Wisconsin Department of Transportation

Transmittal No. 429

August 2023

Standard Detail Drawings Updates

INLET COVERS TYPES BW MANHOLE COVERS TYPES K, J, J-S, L, AND M

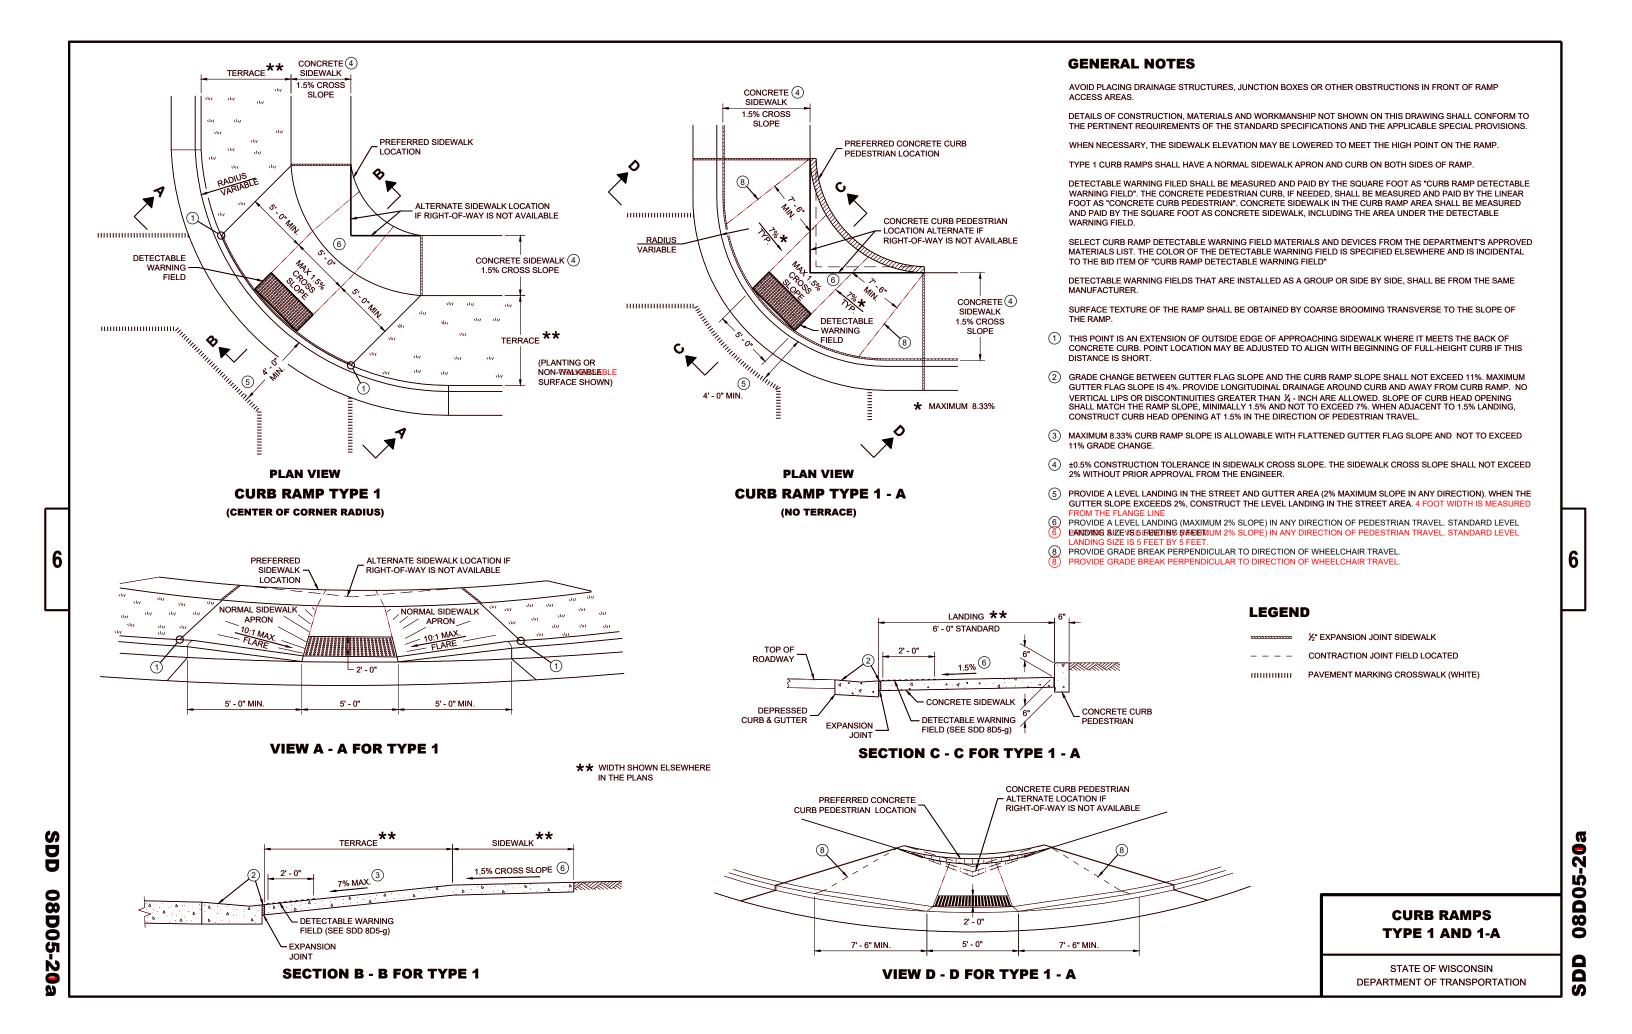
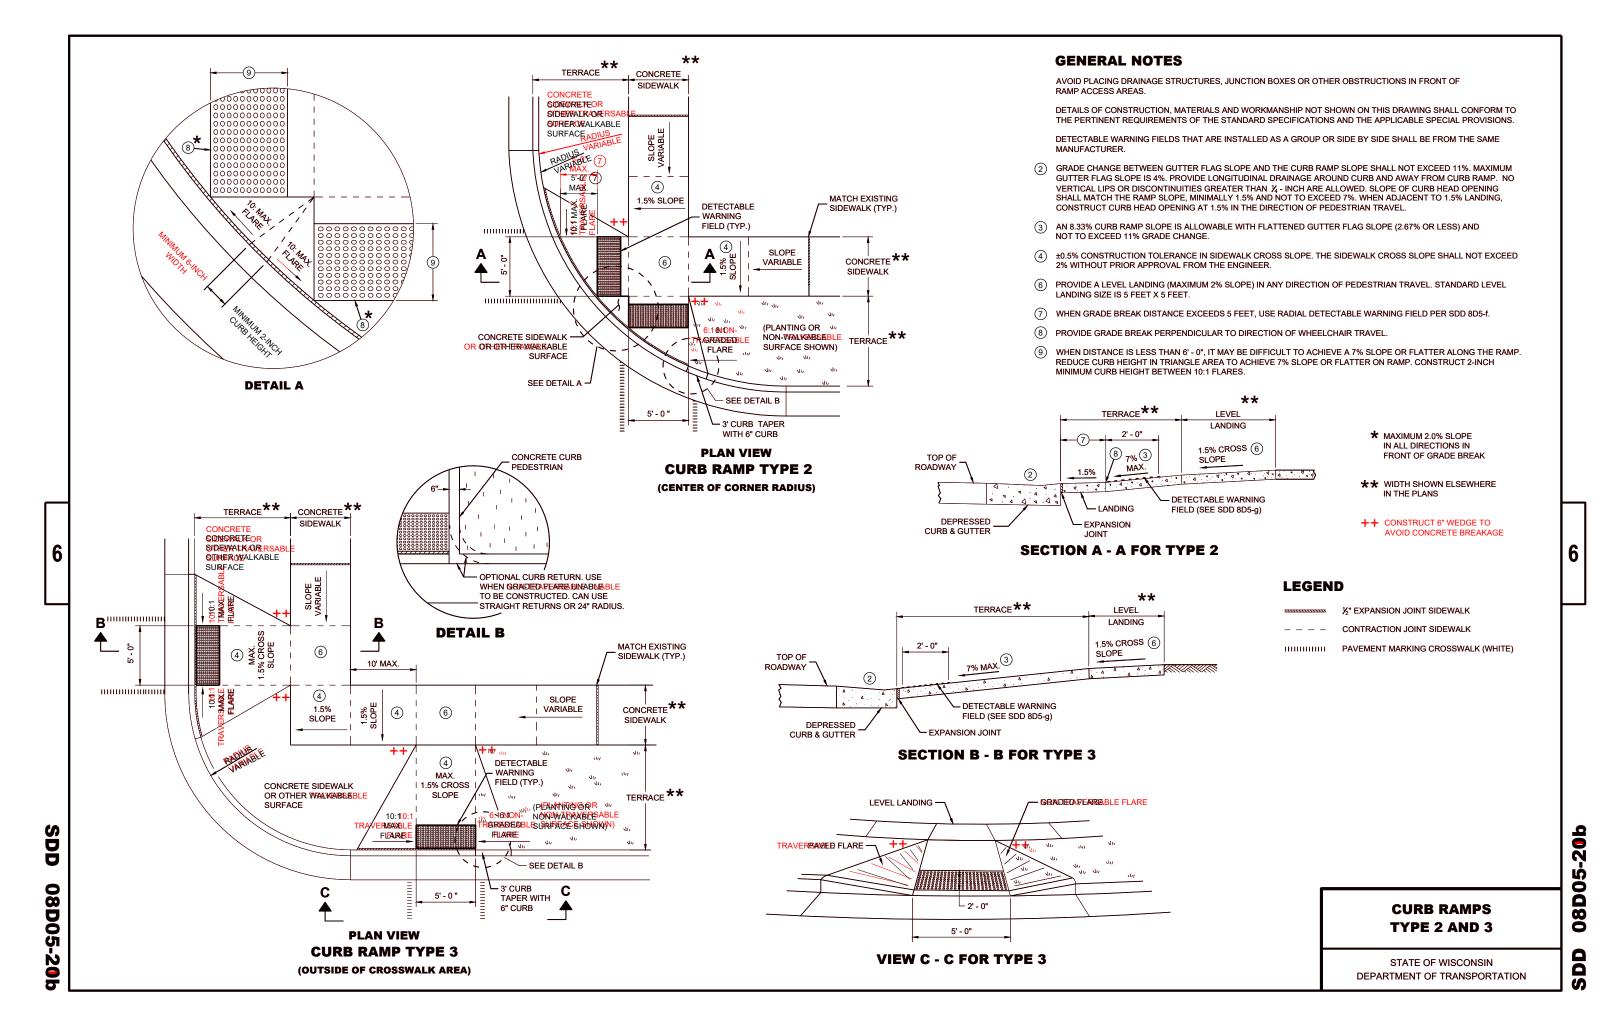
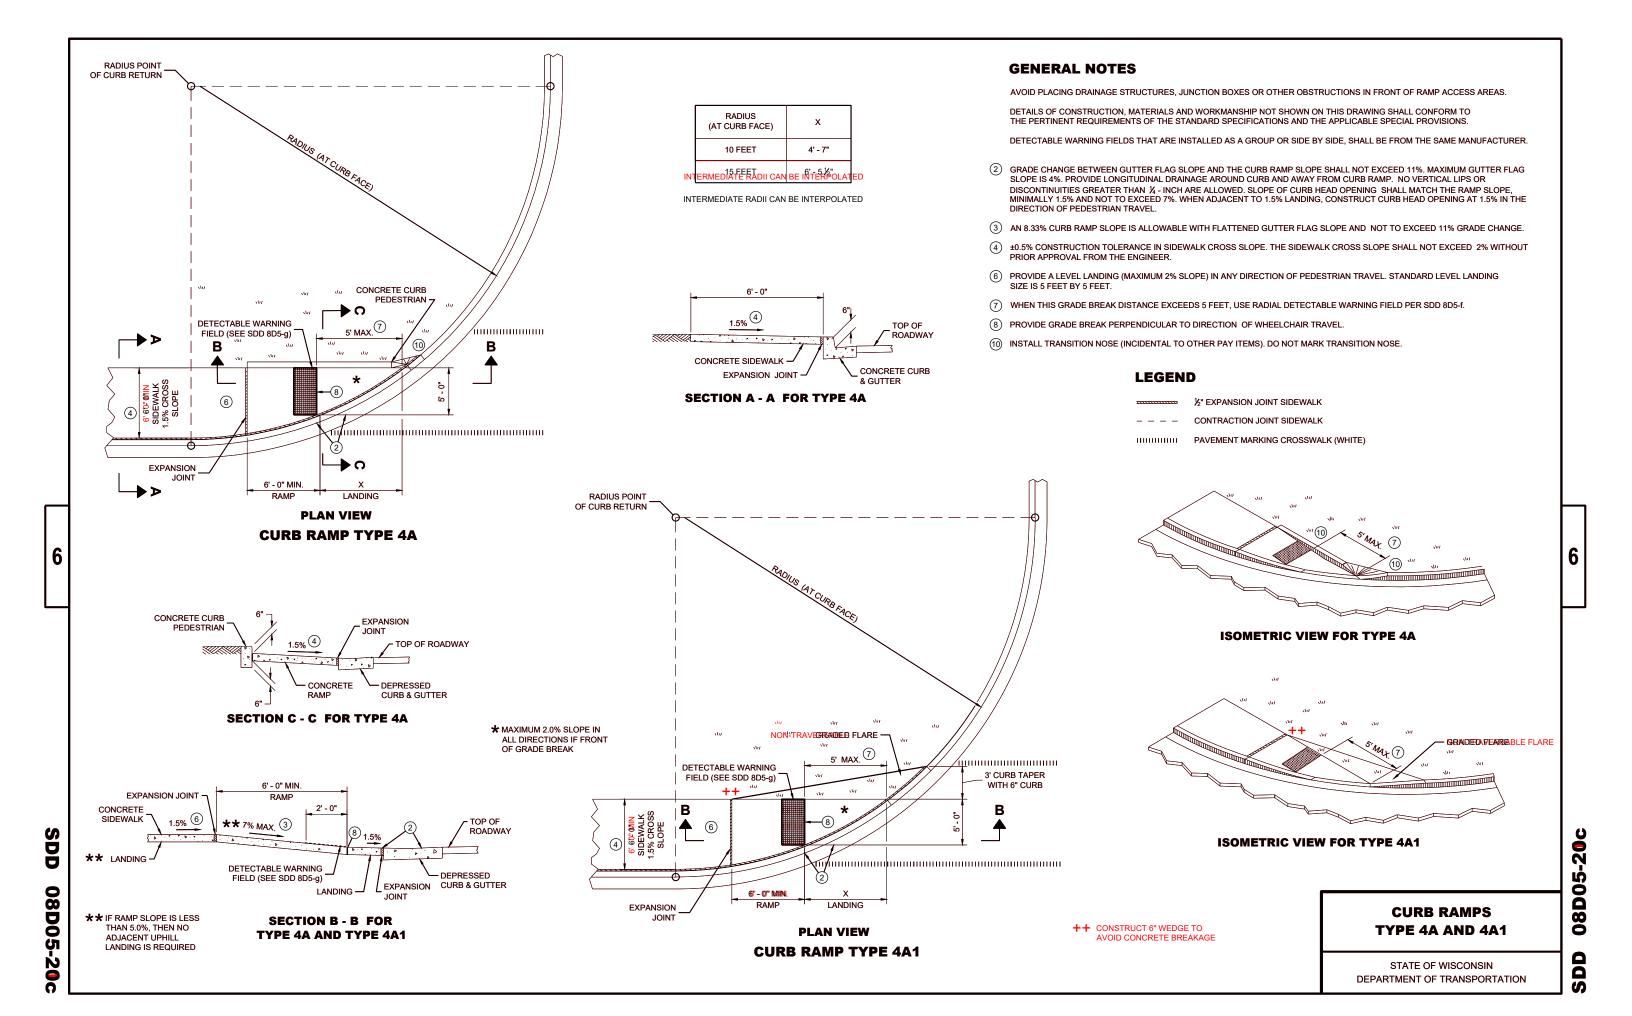
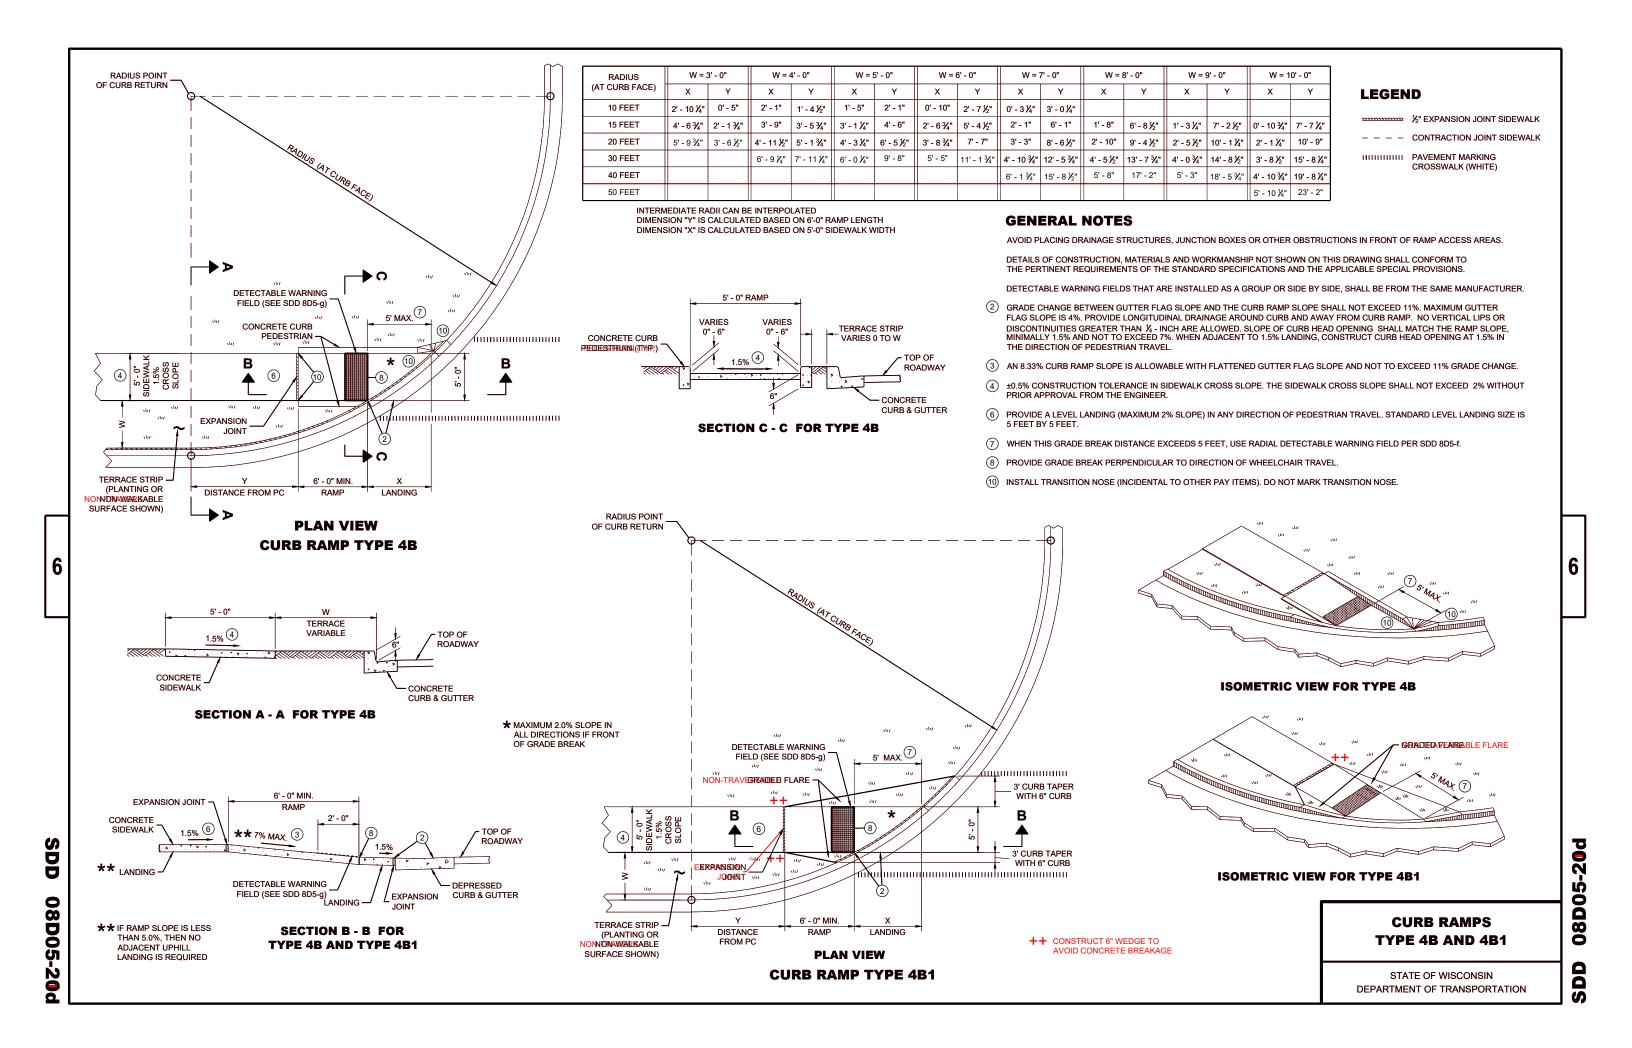
8A05	v.20	Added a detail for a Type V-B bolt down cover. Updated the Type V details to the most recent specifications
8D05	v.21	Updated all flare slope notes with traversable and non-traversable. Adjusted location of slope arrows on Type 6 ramps at islands. Removed lower landing lengths over 5' (X) for Type 4 ramps. Updated and added notes for sidewalks and paths to Type 8 ramps
8D18	v.4	Removed note for base aggregate payment. Updated the designer notes associated bid items.
8D19	v.4	Removed note for base aggregate payment. Updated the designer notes associated bid Items.
